# **Requests for Additional Information - PANDA RAIs**

ESBWR NRC Meeting  
Closed Session  
June 25, 2003  
Rockville, Maryland

## Test P2

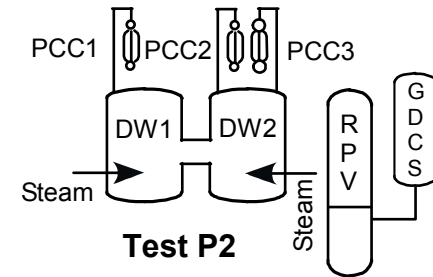
Effect of Leaky Check Valve

Initial system pressure response comparisons

Steady PCCS flow with declining DW-WW press difference

GDCS/RPV vessel level after 1200s

WW water temperature comparisons

WW air partial pressure comparisons

## Test P6

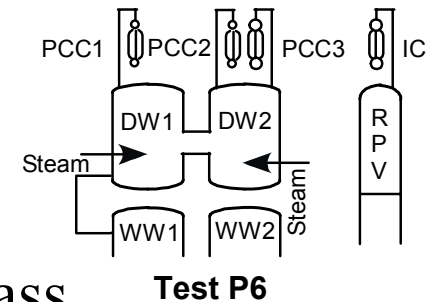
Why combine IC operation and steam bypass

Why does WW-DW press diff decrease slower than in P1/8

Why do the PCCs still work when WW-DW  $\Delta p = 0$

Press diff blip at 42,000 s

Over-prediction of VB flow between 15,000-25,000s
